TURTLE CREEK SUBDIVISION, **PHASE THREE**

APPLICATION NUMBER 16 DATE May 15, 2008

DETAIL SITE PLAN

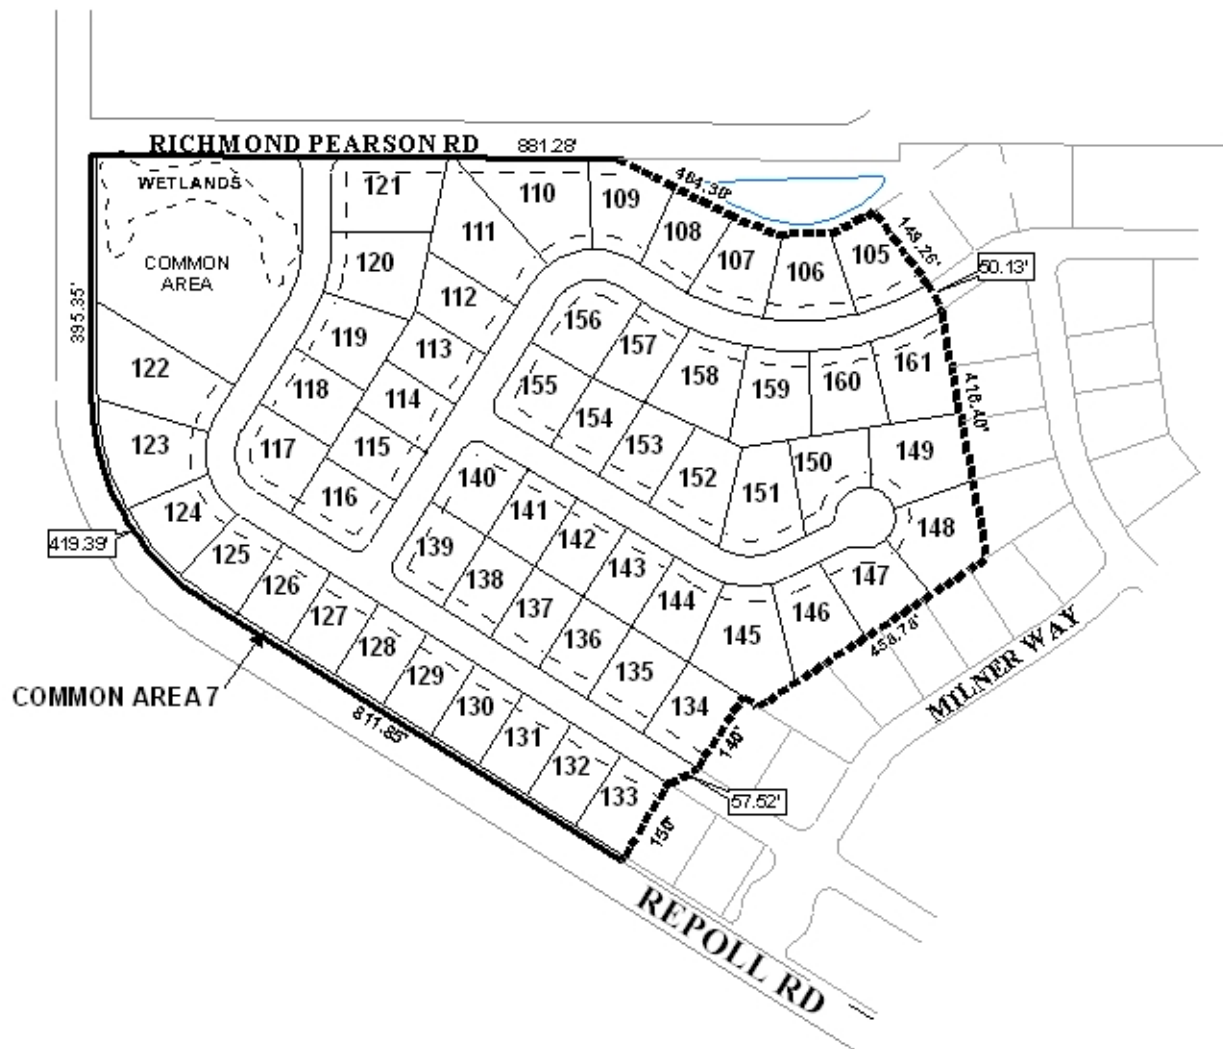
The site fronts Repoll Road and Richmond Pearson Road, both minor streets with adequate rights-of-way. The roads within the subdivision will connect to existing roads in Phases One and Two, and to Richmond Pearson Road. All proposed roads appear to meet minimum dimensional requirements with the exception of the cul-de-sac: the length of the cul-de-sac exceeds that recommended by the Subdivision Regulations, and the diameter of the cul-de-sac is below the recently amended minimum requirement of 120-feet. A waiver of Section V.B.6. of the Subdivision Regulations for length may be appropriate, subject to approval in writing by Mobile Fire-Rescue, and if the diameter of the cul-de-sac is revised to meet the new requirements of the Subdivision Regulations (which comply with the 2003 International Fire Code, as adopted by the City of Mobile).

Multiple lots will have frontage on Repoll Road, Richmond Pearson Road, and new streets within the subdivision. All lots should be denied direct access to both Repoll Road and Richmond Pearson Road. Furthermore, all lots within the development should be limited to one curb-cut each, with the size, design and location to be approved by County Engineering.

The 25-foot minimum building setback is shown and labeled on the plat and should also be depicted on the final plat. The lot size information on the preliminary plat should also be retained for the final plat.

- 1) Revision of the plat to depict the correct diameter for the cul-de-sac;
- 2) Construction of all streets to Mobile County and the City's 2003 International Fire Code standards, and acceptance of the streets by Mobile County prior to the recording of the final plat;

- 3) Placement of a note on the final plat stating that all lots are denied direct access to Repoll Road and Richmond Pearson Road;
- 4) Placement of a note on the final plat stating that each lot is limited to one curb-cut, with the size, design and location to be approved by Mobile County Engineering;
